PLANNING REPORT

SUBJECT: REEDLODGE PTY LTD - MCU - SHOPPING CENTRE - LOT 78 SP152626 - 232 BYRNES STREET, MAREEBA - MCU/17/0011

MEETING DATE: 20 December 2017

MAREBA SHOPPING CENTRE	
252 BYRNES ST. MAREBA	
CLIENT - GICENTRE GROUP	
SITE PLAN	
DRAWING TITLE	DATE
SHEET NO.	4777
DRAWING NO.	SD1002
	G

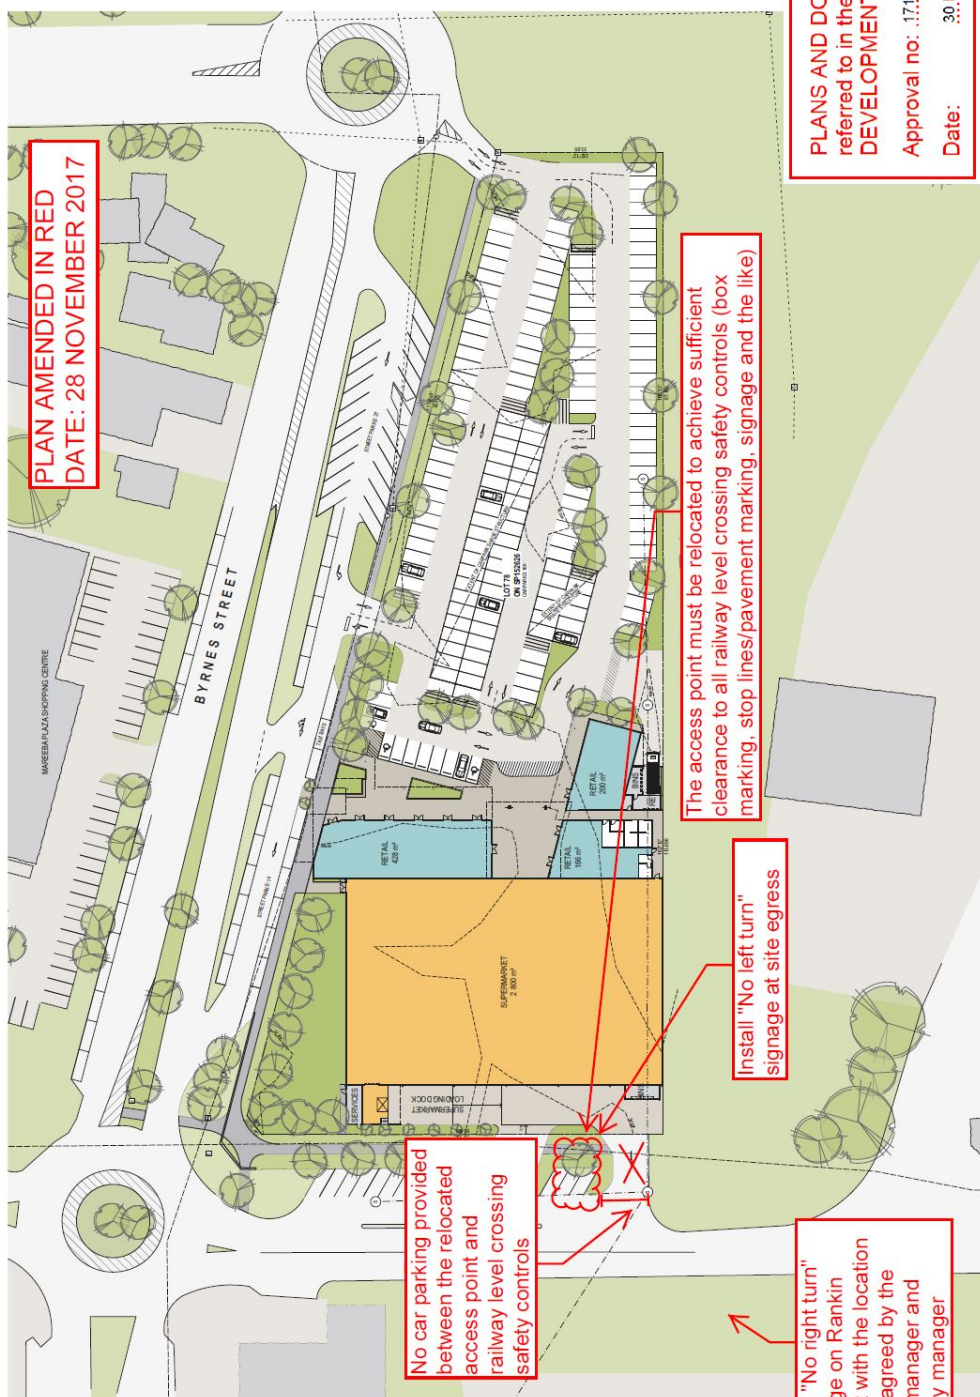
Trolley bay areas must be provided on the site generally in accordance with Drawing No. SD1002 Issue G.

The applicant/developer must ensure that the development is provided with at least 139 on-site car parking spaces, generally in accordance with Drawing No. SD1002 Issue G, which are available for use solely for the parking of vehicles associated with the use of the premises. All car parking spaces must be sealed, line-marked and appropriately drained prior to the commencement of the use, to the satisfaction of Council's delegated officer.

Car parking shade structures must generally be provided in accordance with Drawing No. SD1002 Issue G.

- 4.5.4 On street car parking and service access generally in accordance with the extent of works shown on Drawing No. SD1002 Issue G (as amended by the Department of Transport and Main Roads).

- 4.5.5 A paved footpath, including kerb ramps and associated tactile indicators must be constructed on Rankin Street to the general extent indicated on Drawing No. SD1002 Issue G. The footpath must be constructed in accordance with the FNQROC Development Manual. No section of paved footpath is to be less than two (2) metres in width.

- 4.6.3 The landscape plan should be generally consistent with landscaping shown on the submitted site plan (Drawing No. SD1002 Issue G) and demonstrate compliance with the Landscaping Code. Plant species are to be generally selected from the Plant Schedule in Planning Scheme Policy 6 - Landscaping and preferred plant species.

TMR Layout Plan (664 - 1.60km)

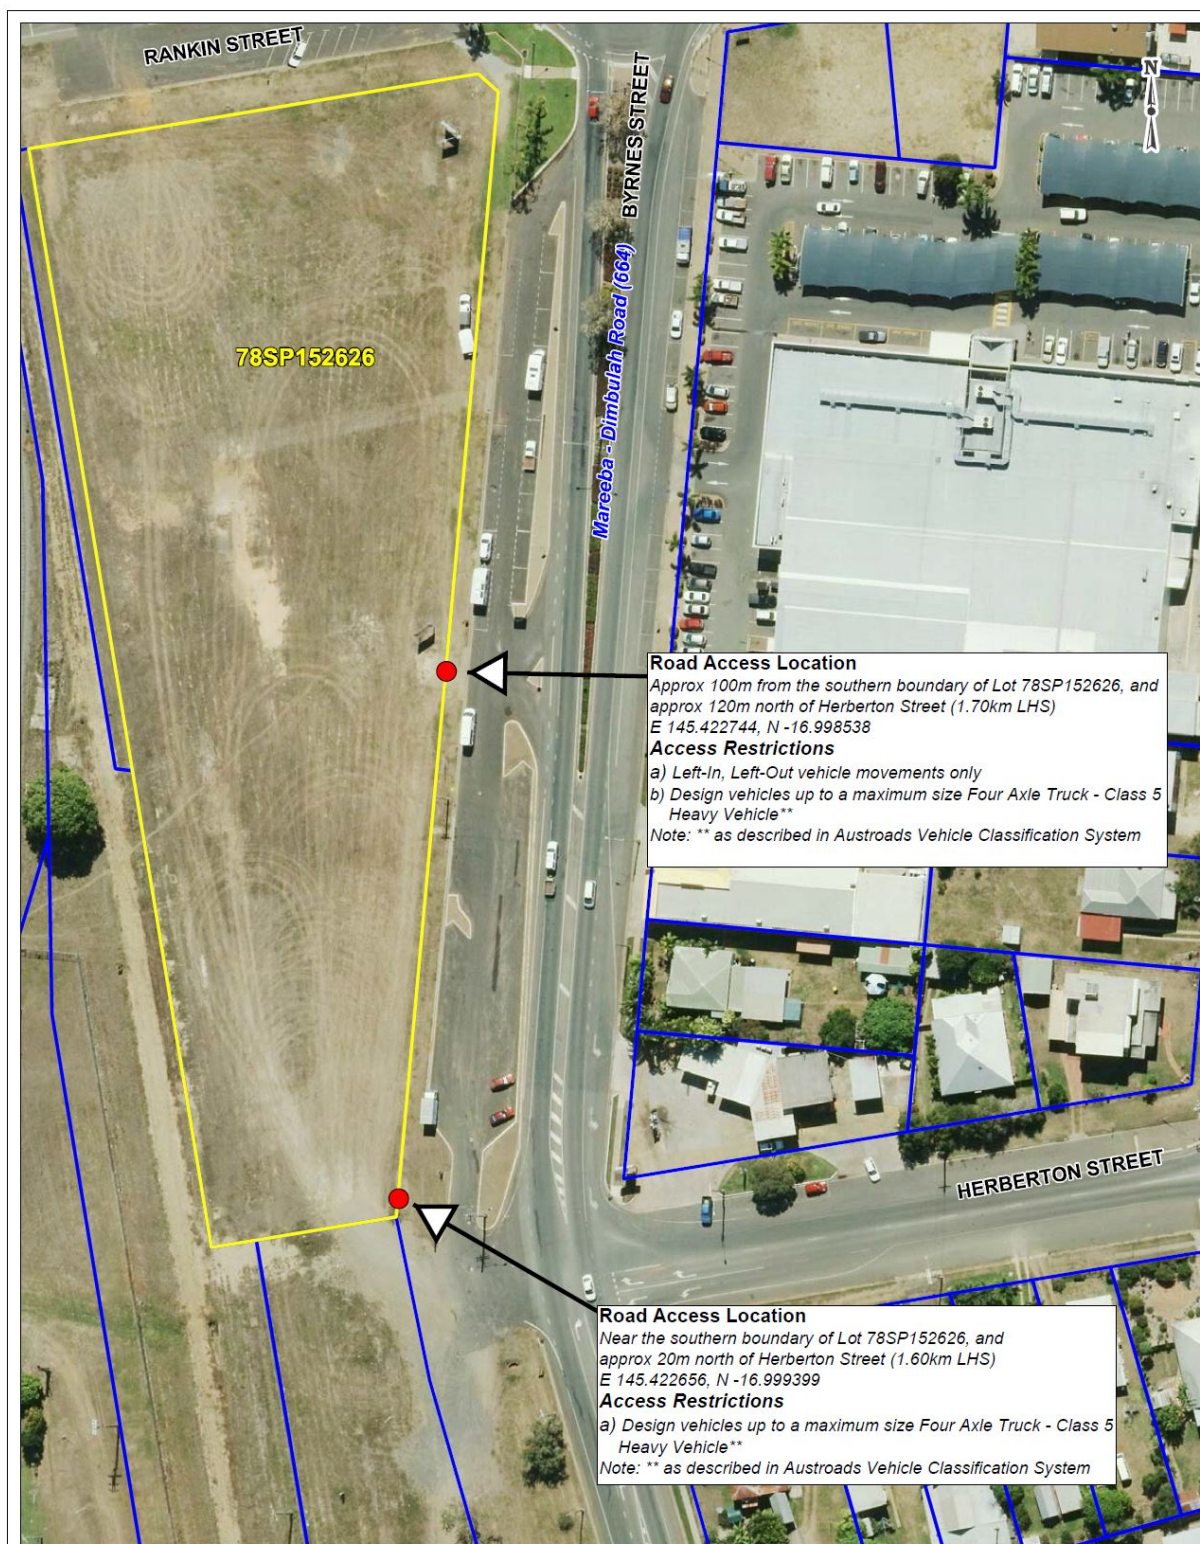
1.	The road access location(s) between Lot 78 on SP152626 and the state-controlled road, is to be in accordance with the TMR Layout Plan (664-1.60km) prepared by the Department of Transport and Main Roads, dated 27 November 2017, reference TMR17-22687 (500/310), Version C under section 62(1) of the <i>Transport Infrastructure Act 1994</i> .	At all times.
